Product Change Notification / LIAL-09UEWG307

CCB 4395 Final Notice: Qualification of MMT as an additional assembly site for selected Micrel products available in 16L VQFN (3x3x1.00mm) package.

CCB 4395
Pre and Post Change Summary
PCN #: LIAL-09UEWG307

UNIS

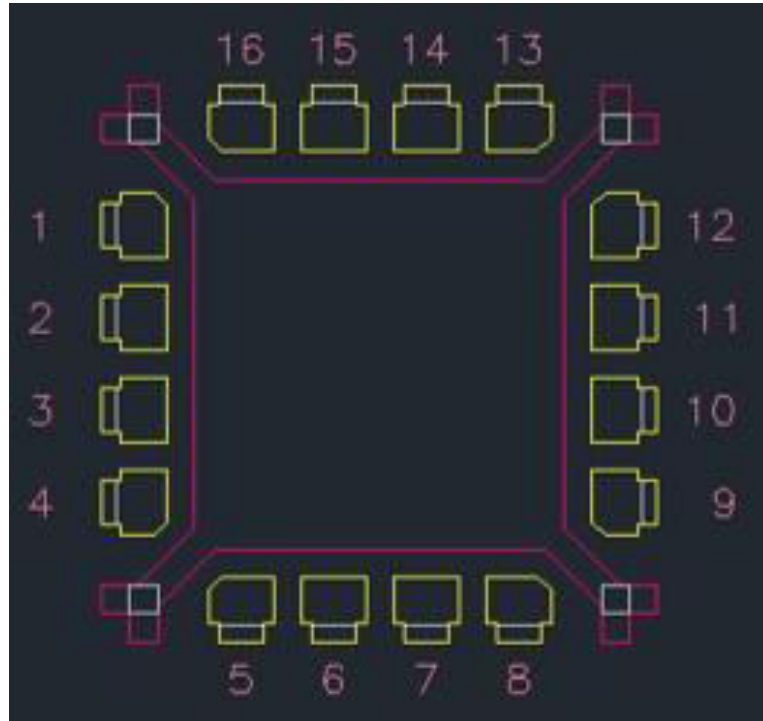
Lead Frame Lead Lock	No
Lead frame paddle size	69 x 69 mils

MMT

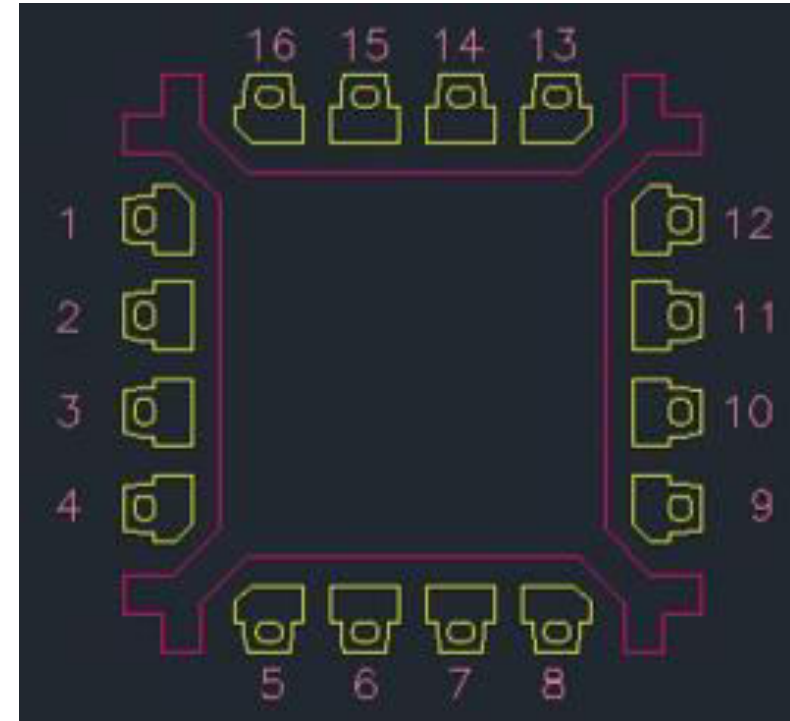
Lead Frame Lead Lock	Yes
Lead frame paddle size	75 x 75 mils
